# Attachment F1

**Submissions**

D/2023/878

RENOTIFICATION due to the lodgement of amended plans and reports

3D view - Cor Challis & Victoria - Proposed

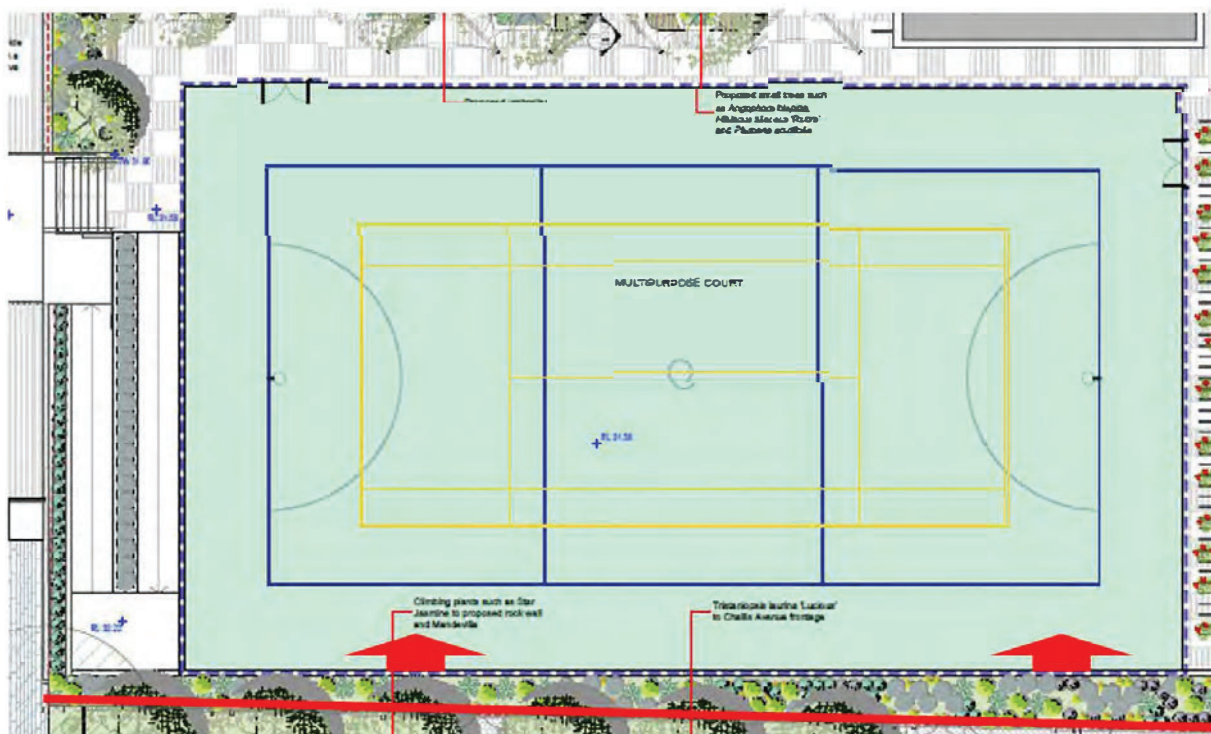
The previous proposal (left in the comparisons above) provided better framing of the façade to Challis Avenue and greater vertical rhythm, appropriate for the Heritage Conservation Area. This corner change, rather than decreasing the horizontal emphasis of the proposal (to favour vertical bays and composition in the Heritage Conservation Area) has done the opposite by increasing the horizontality of the corner, further exacerbated by the black window framing.

Council should insist this is reviewed and changed.

### Remove Fencing to the edge of the Rooftop planter bed (Point 7)

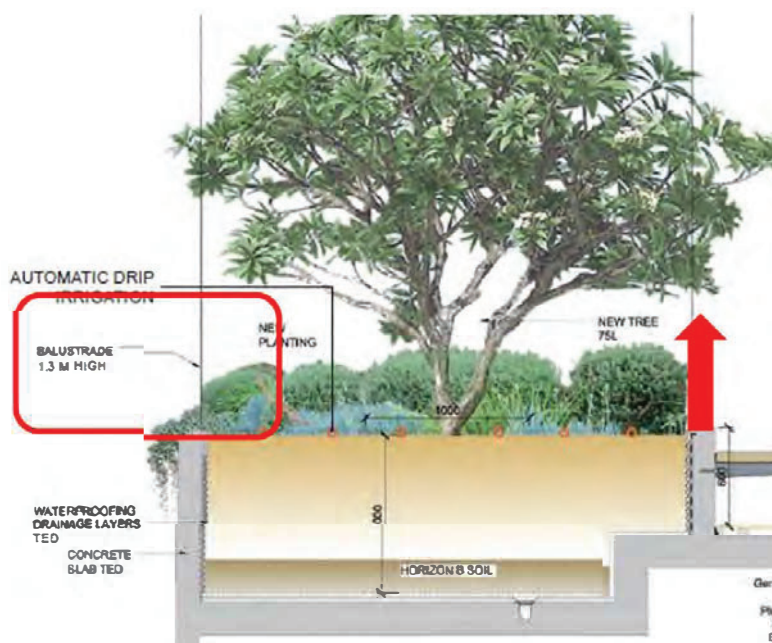
As previously recommended/requested in our prior submission (1/11/2023), there should be no need for a balustrade to the edge of the rooftop landscaped bed. It would be better to provide deeper soil for sustaining planting by having the landscaped bed act as the balustrade to meet the BCA requirements, while also reducing streetscape impacts of the fencing to the rooftop edge to the street.

Instead, the applicant is proposing a “balustrade”/fence above the planter bed. Leading to an effective fence at the rooftop edge fronting the street of 1.9m.

Figure 2: Proposed plans for Bethania building with red circle proposing to reduce size

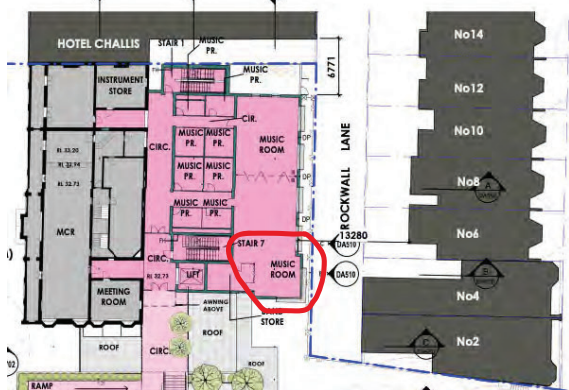
Second, the south-west corner of level 1 of the proposed Bethania building exacerbates the loss of view that I will incur yet does not appear to serve any purpose (see Figure 2). The rooms (ground floor and level 1) bounded by this corner are intended as a 'work' room and music room, respectively, neither of which surely require the extended corner space that the design proposes, and which will further impinge on my view of iconic elements.

⇒ **I request that a revised design of the Bethania building be prepared which excludes the enlargement of the south west corner thereby reducing the impact on my view by reducing the width of the building. There will be no impact on the proposed amenity.**

Figure 3: Proposed Bethania building design

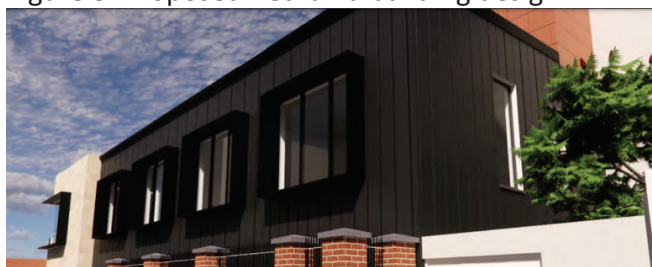
Third, the design of the proposed Bethania building is wholly inconsistent with the character and aesthetics of the heritage buildings surrounding it including Garcia, Hotel Challis and the terraces along Rockwall Crescent. The facades of all these structures are in light coloured stone, yet the proposed Bethania will present as a visually unappealing and obtrusive black cladding which will dominate the aspect from my property and retain heat, of relevance given the proximity of the proposed structure to my residence (Figure 3). The proposed black cladding for the lower levels of the Bethania building is also inconsistent with the *Stakeholder Engagement* report (see pages 29) which states “using a lighter colour on the second level”), following community consultation.

⇒ **I request that a revised design of the Bethania building be prepared to replace the black cladding material with light coloured stone to respect the heritage nature of the surrounding buildings.**

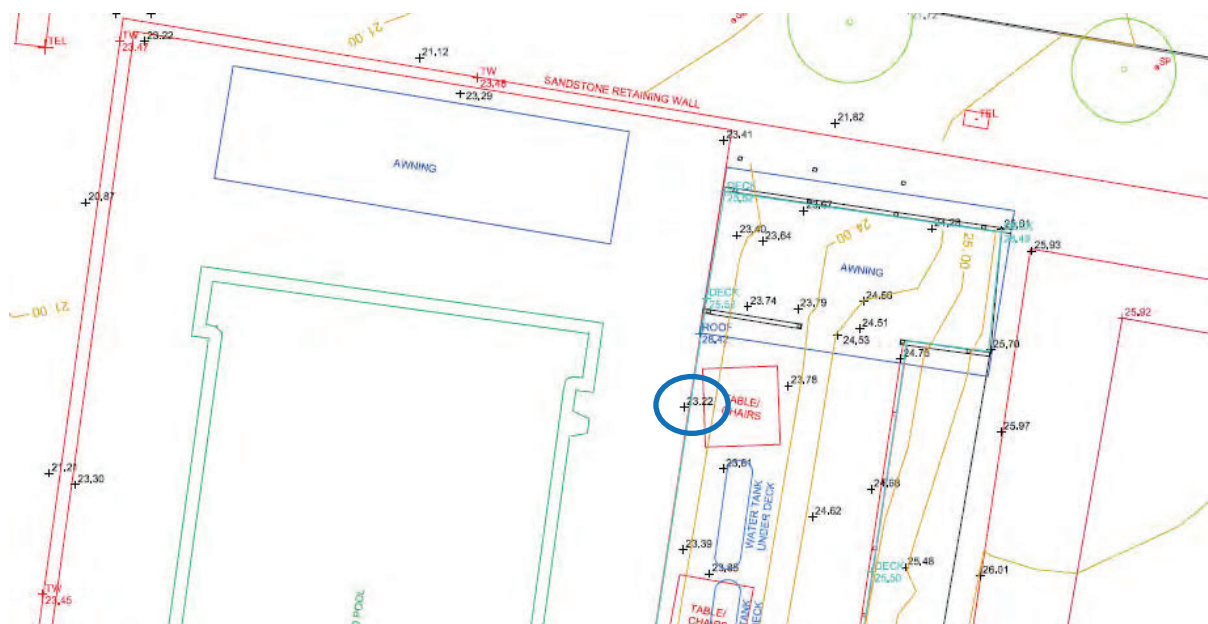
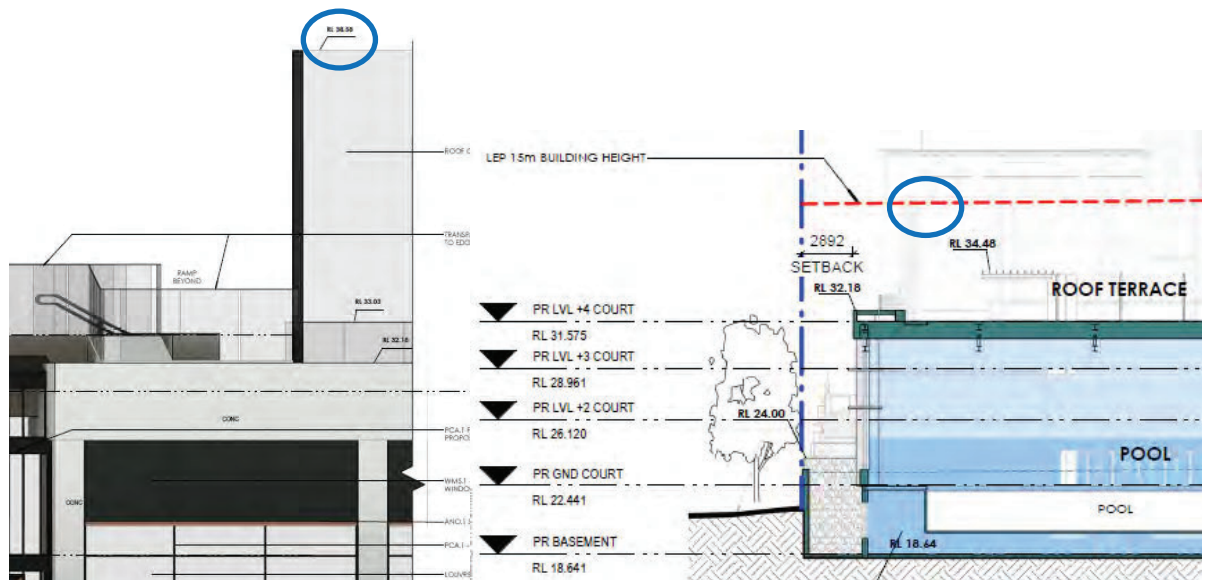
It would be inappropriate to exclude the significant tennis court fencing on the rooftop from the Building Height measurement on the basis that it is “and the like” to the items cited in the definition above for the following reasons:

- The fencing is significant – being 7m high, and measuring approximately 33m x 23m, from scaling of the plans as it is not dimensioned (or a perimeter of around 110m);
- The fencing is stated as chain wire in the SEE; and despite euphemisms on the plans that it will be transparent (thereby implying not seen), it will be very visible;
- The items excluded in the definition are small, skinny or “one-off” minor items with minimal visibility (like flagpoles, masts, chimneys, flues “and the like”);
- The proposed large and expansive fencing is not “and the like” in the context and intent of the definition;
- The fencing is a long and co-ordinated structure that will be very visible (one does not need to look far to the visual impact given the existing tennis court on the corner of Challis Avenue and Victoria Street:

- Given the court runs east-west, it is likely sun control devices may be erected over time, which may not be structures.

#### Heritage and Tree Impacts (Point 4)

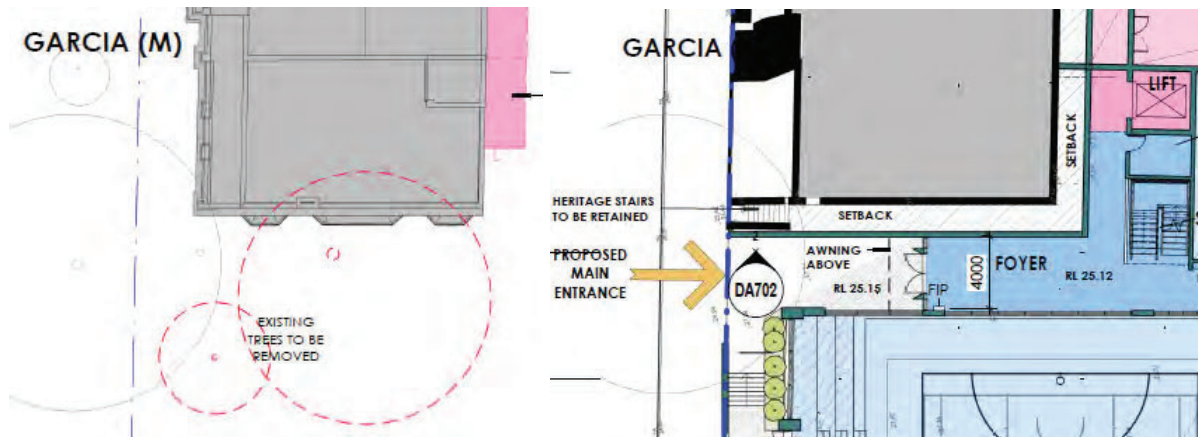
This issue has been explained above. The setting of the Garcia building heritage item and the Conservation Area will be negatively compromised by the proposed rooftop tennis court and high fencing, in its current position.

There is also a significant tree adjoining the Garcia Building, to its west. This tree is proposed to be removed, as shown below.

#### Retain Tree and increase eastern setback (Point 6)

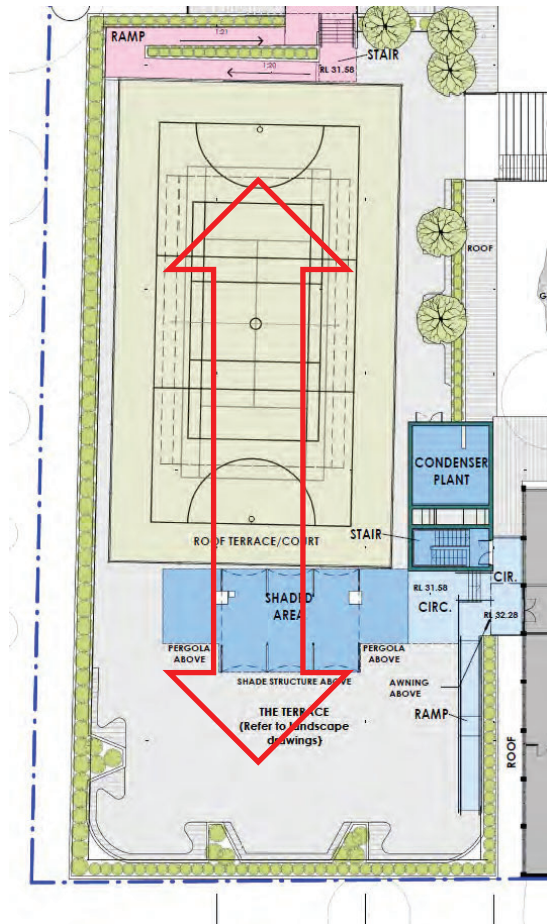
As outlined above related to Point 4, the existing significant tree, heritage impacts and intent to establish a main entry warrant and justify the existing tree to the west of the Gracia Building to be retained.

The new multi-function building should be moved to the west to allow retention of this tree. Given the rooftop has ample space for a terrace and there is potential for ancillary space to the south, this is a reasonable recommended change.

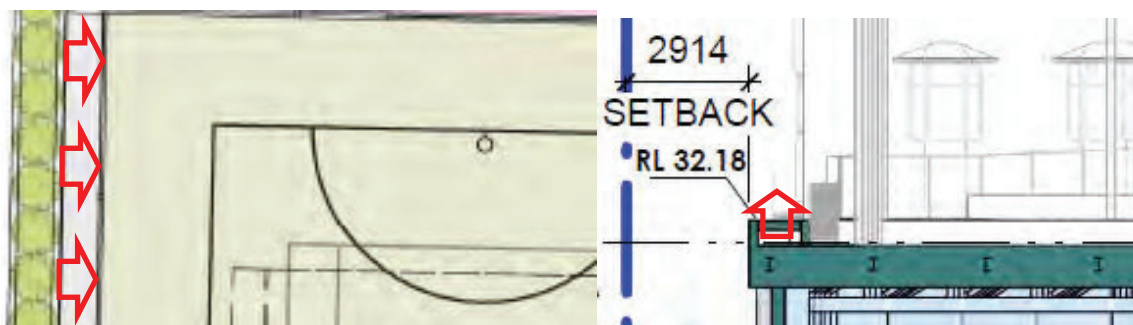
The height of the rooftop tennis court fencing should be reduced. 7m seems excessive for young girls/teenagers.

The fencing posts and fencing should be black in colour.

Further, to provide greater landscaping, and importantly to allow vines to grow on the fence to soften its visual appearance, it is recommended the perimeter landscape bed be widened to abut the tennis court fencing. Any access to the landscaped bed could be from gates or
